**REVIEW OF HYDROLOGY STUDY**

**PD/MTD. NO.** N/A  
**TR/CUP NO.** 201400037  
**TRANS DATE:** 10/01/15

# HYDROLOGY STUDY & LID PLAN for

**CUP 201400037**

**HYDROLOGY STUDY/LID PLAN for CUP 201400037**  
**ACTON RETAIL CENTER FEED STORE and PRIMO RESTAURANT ACTON, CA**

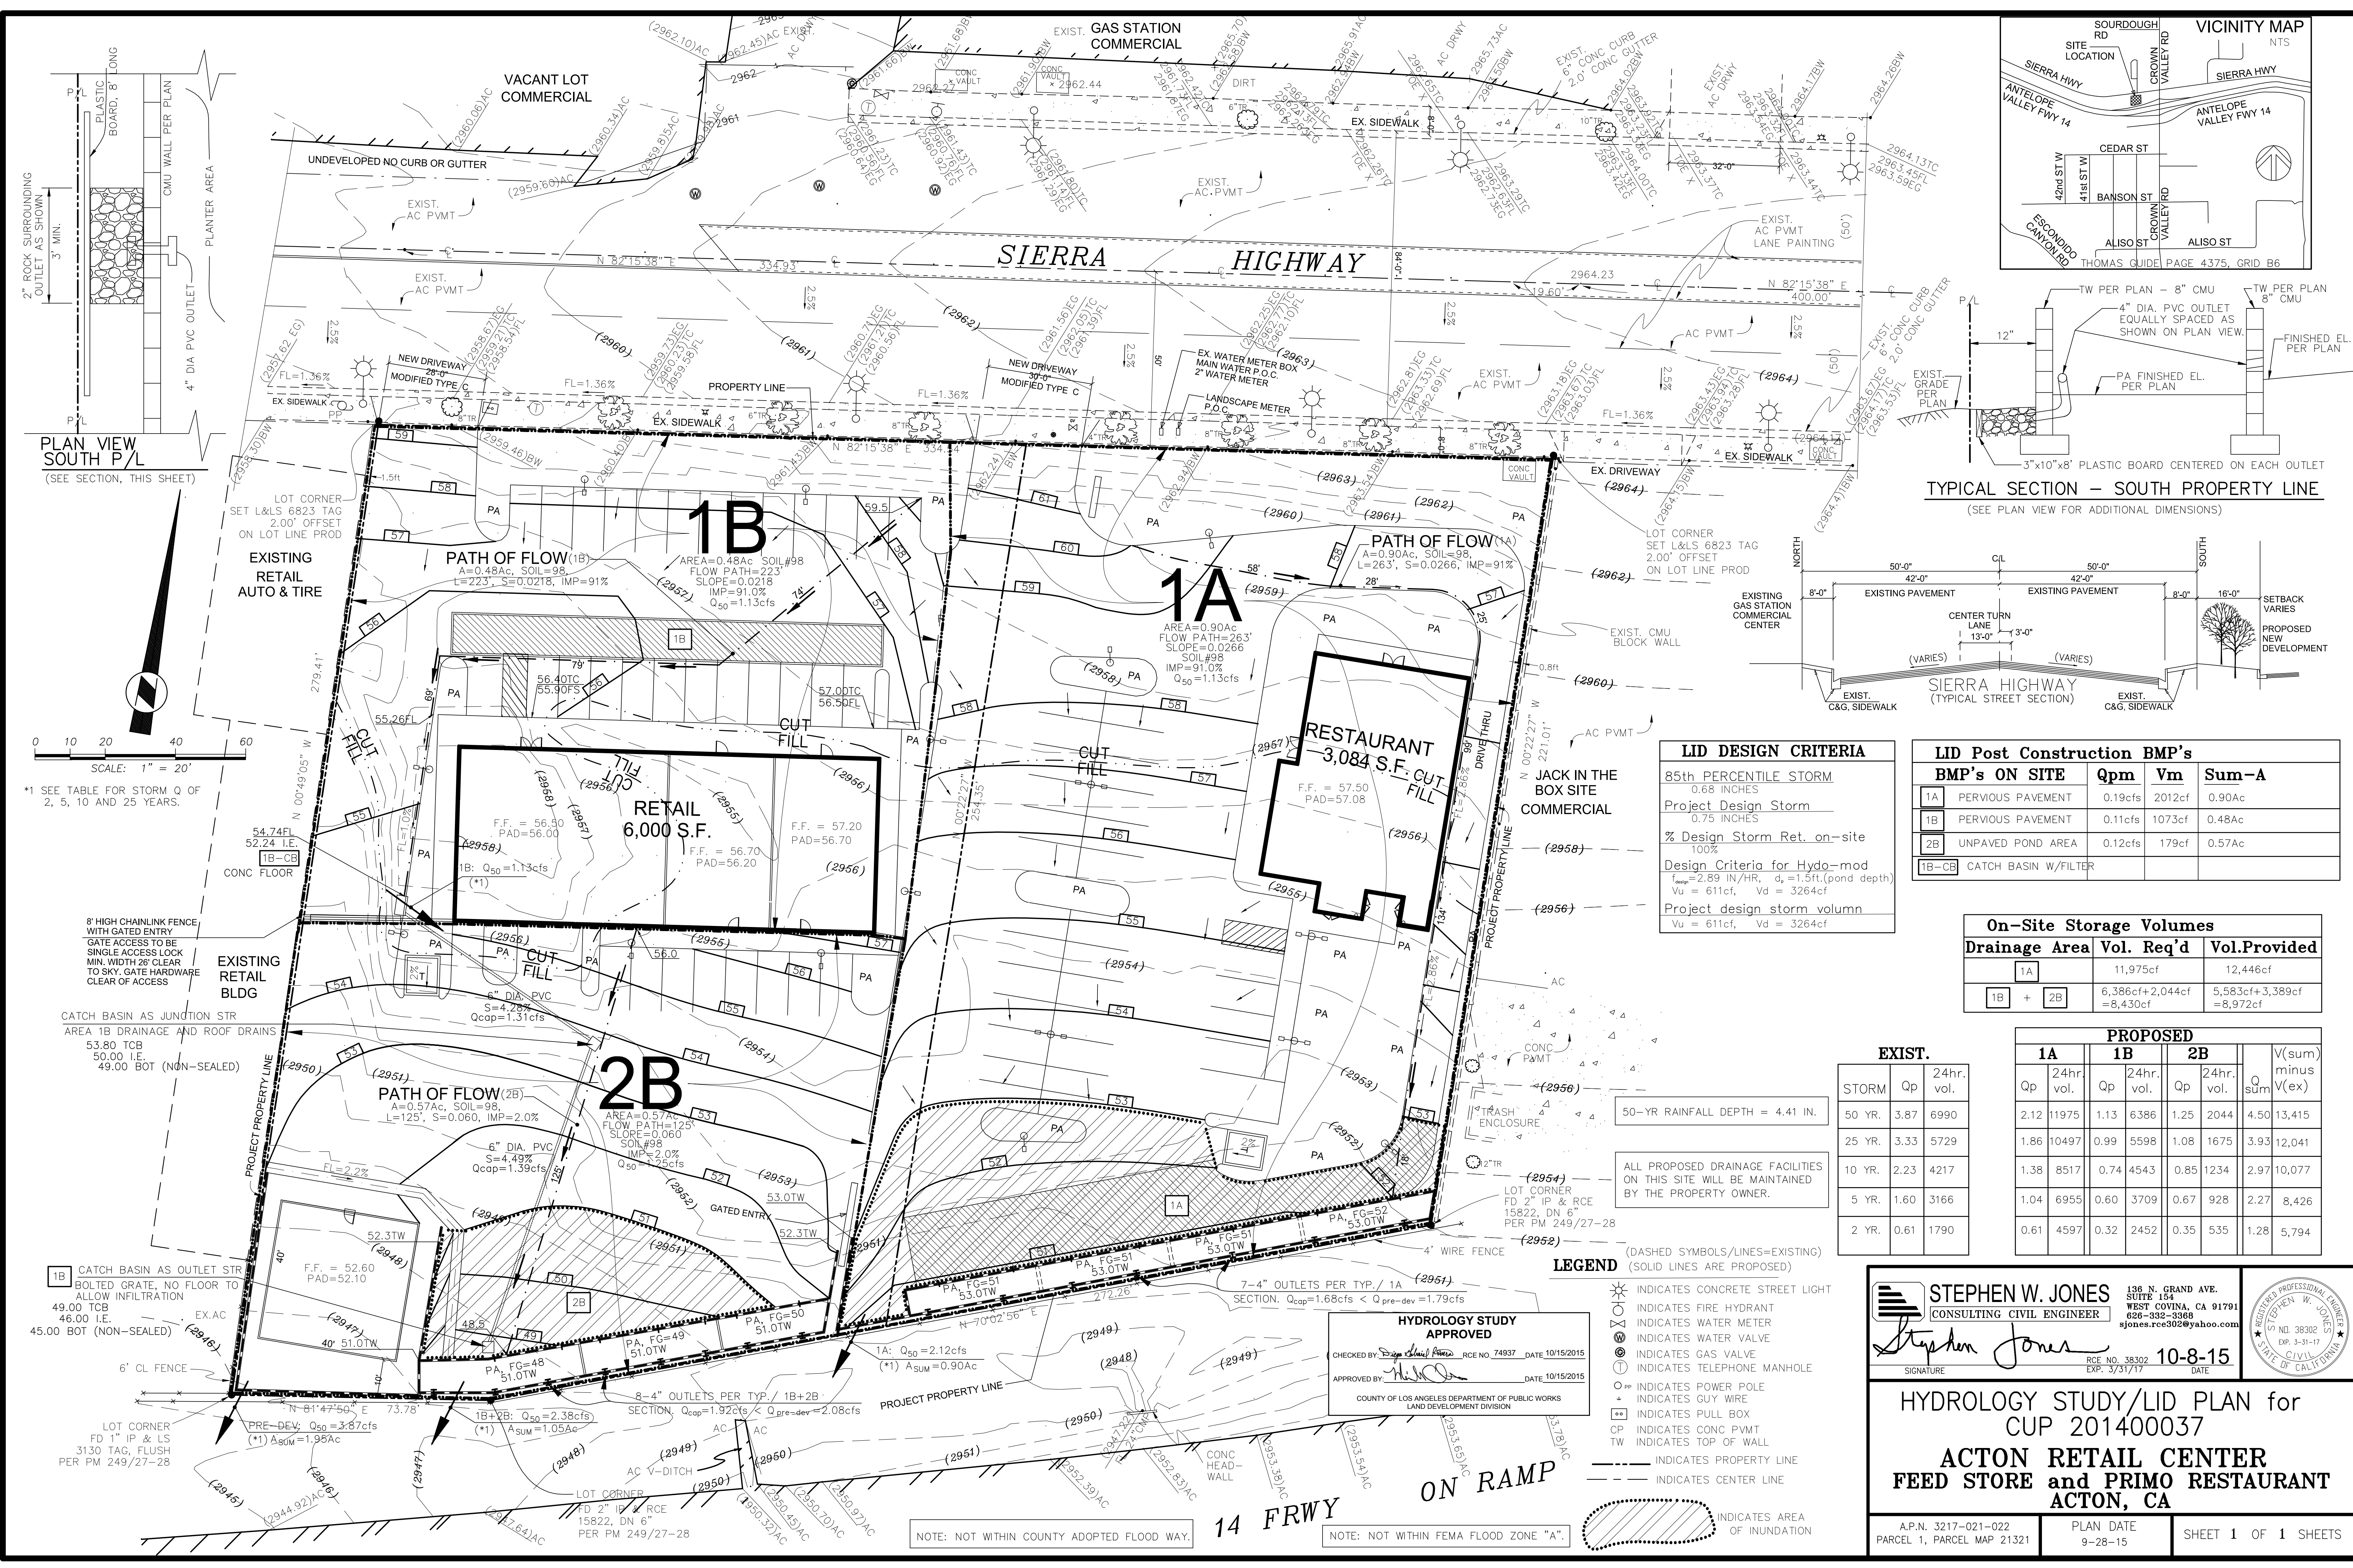
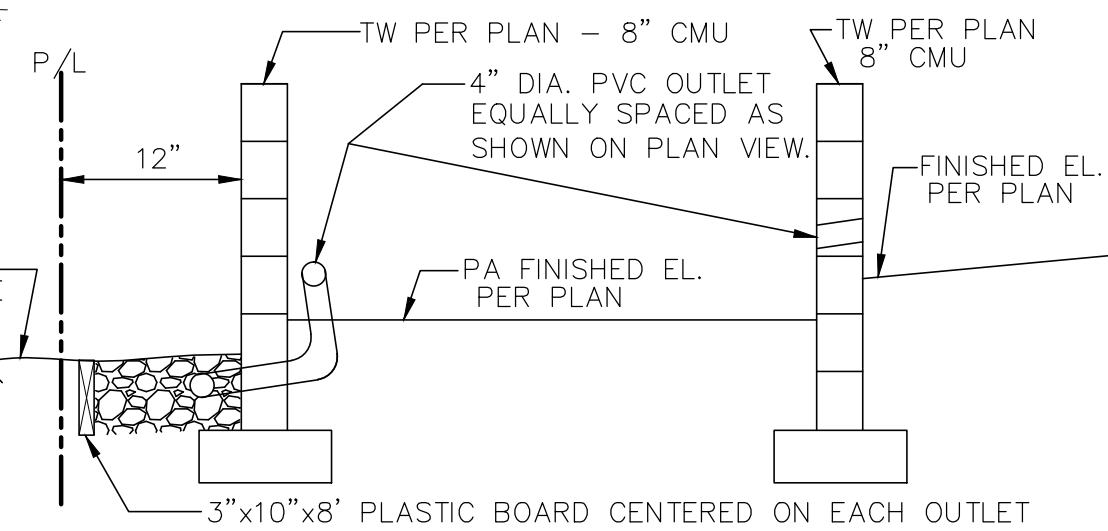
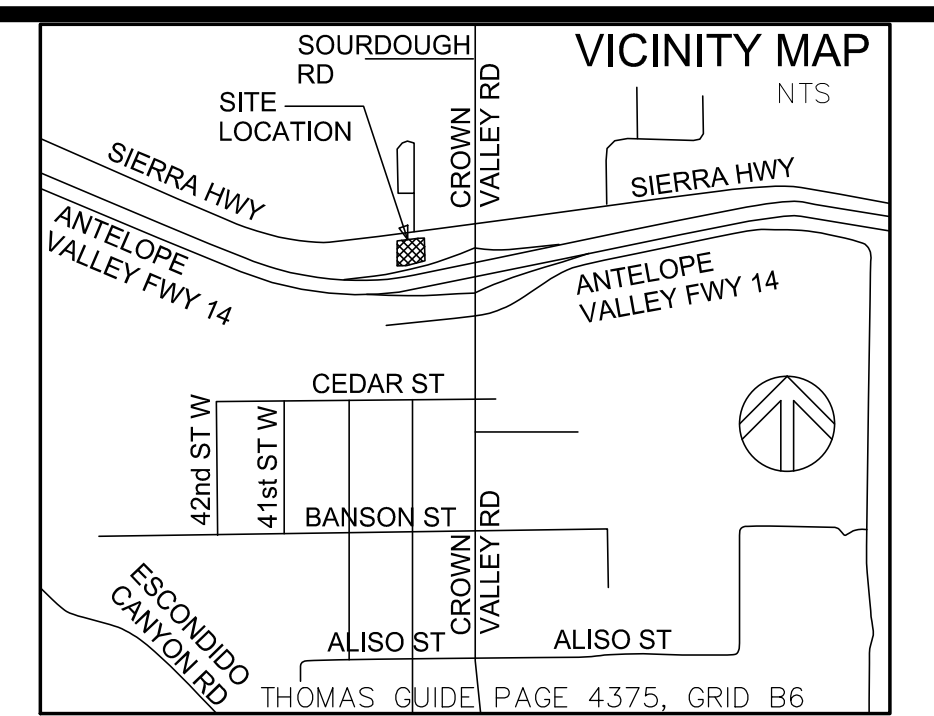
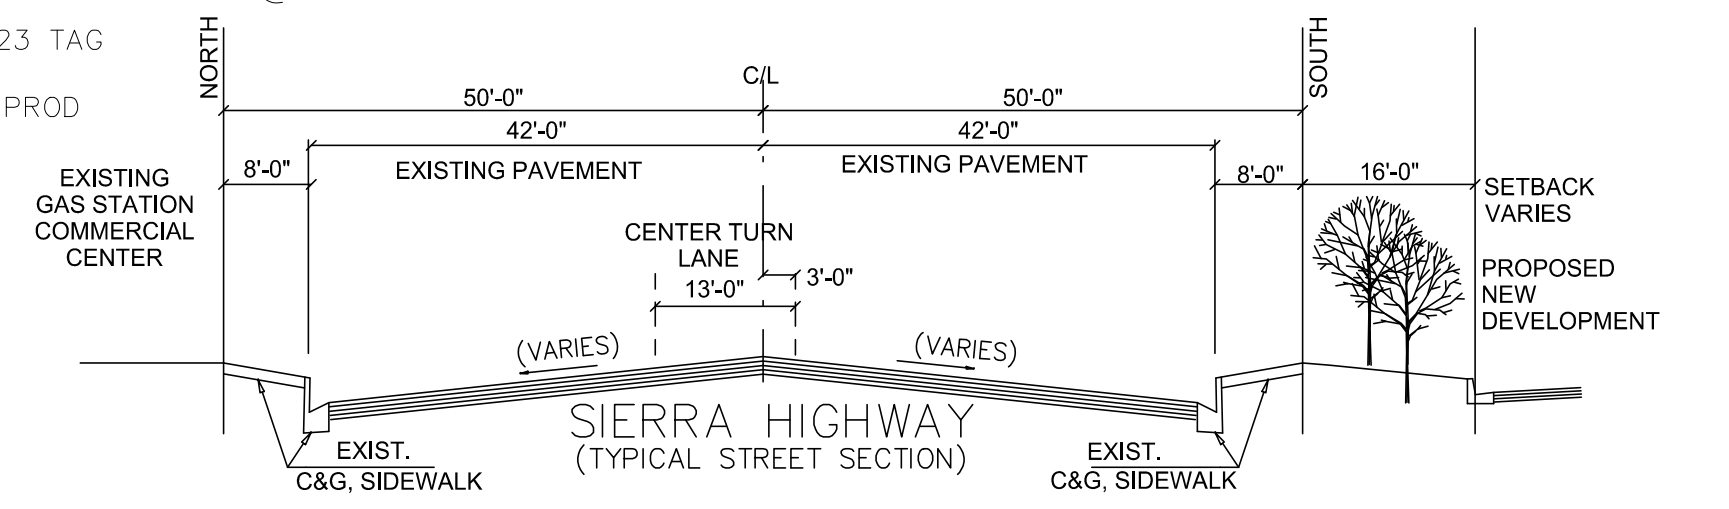
- As stated in Matthew Dubiel's e-mail to Robert Friedman dated September 21, 2015, a revised site plan is required to address all of our comments on the February 26, 2015 memo. More specifically, the site plan needs to reflect the proposed improvements as shown on the approved hydrology study.
